Independent Review of Catastrophic Event Remediation Expenditures

Prepared for:
Firstlight Network Ltd
172 Carnavon Street
Gisborne 4010
Ph. 06 869 0700

Prepared by:
M W Consultants Ltd

Figure 3: Gisborne/ Tuai Tower T142 in March 2023

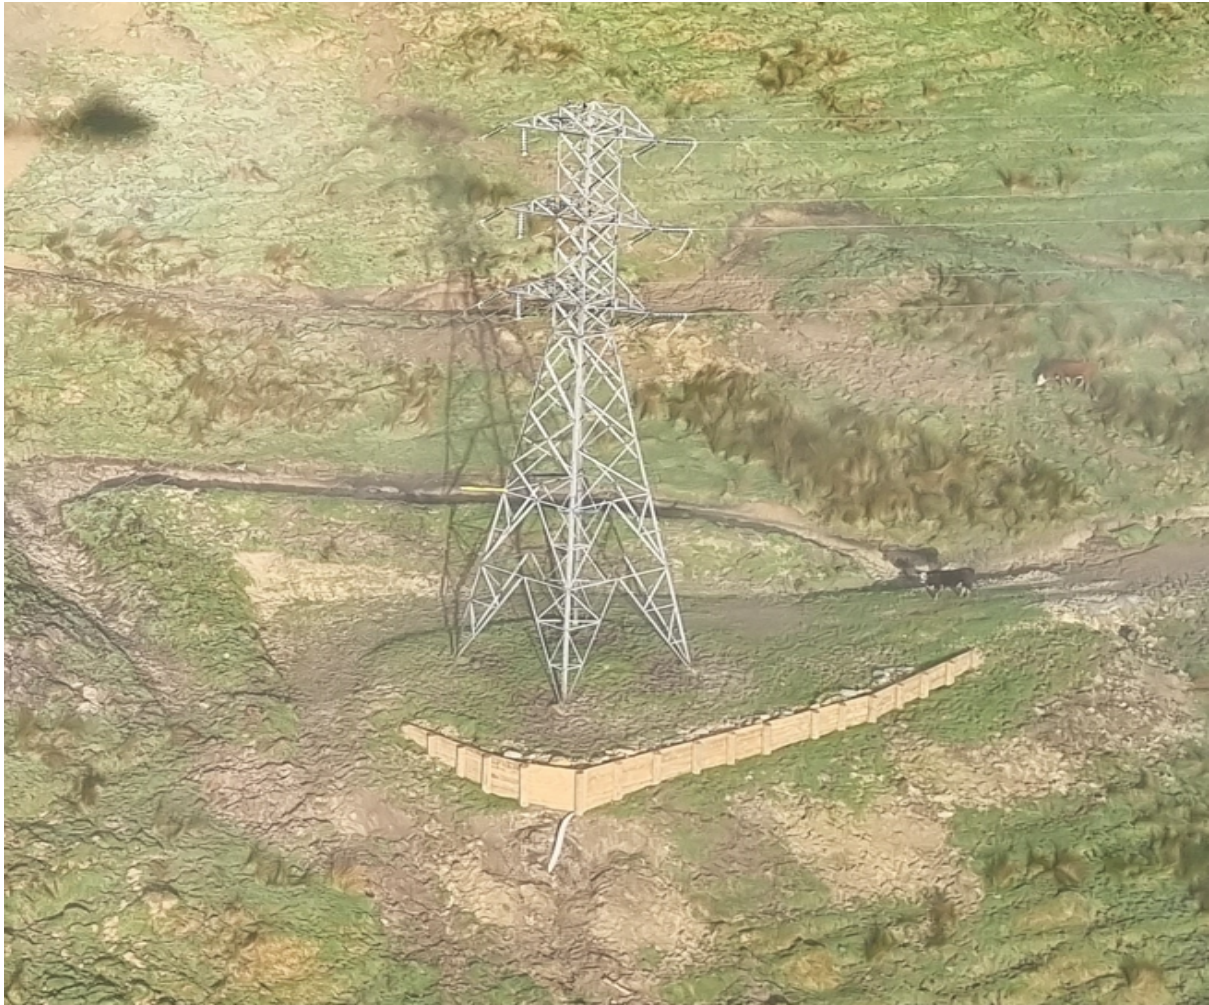
RY2025 Capex Project Name	Assessed Risk	Recommendation
T11 Tower reinstatement	Intermediate risk – a vertical slip face of 12 metre depth within 1.5 metres of tower footing occurred during Gabrielle due to erosion from a stream below (refer to Figures 1 and 2).	Relocate GIS/TUI T11 tower to nearby site and install tower foundation tie beams.
T142 Tower reinstatement	Intermediate risk – major slips above and around tower with cracks in ground across the tower foundations occurred on a scarred hillside as a result of Gabrielle (refer to Figures 3 and 4).	Geotechnical survey, planting and relocation of one circuit to a new structure on ridge.
T302 Tower reinstatement	Moderate risk – ground movement on hillside below the tower on a hillside near Gisborne substation due to Gabrielle (refer to Figure 5).	Ongoing tilt monitoring. Relocation of one circuit to new structure on nearby ridge.
T303 Tower reinstatement	Intermediate risk – several slips below and beside the tower occurred during Gabrielle (refer to Figure 6).	Full foundation reinstatement with drainage and retaining wall.

The scopes for the reinstatement of towers GIS T11 and GIS T142 recognise that the work at tower GIS T11 is planned to occupy two years (RY2025 and RY2026) and that work at GIS T142 has partially already been completed.
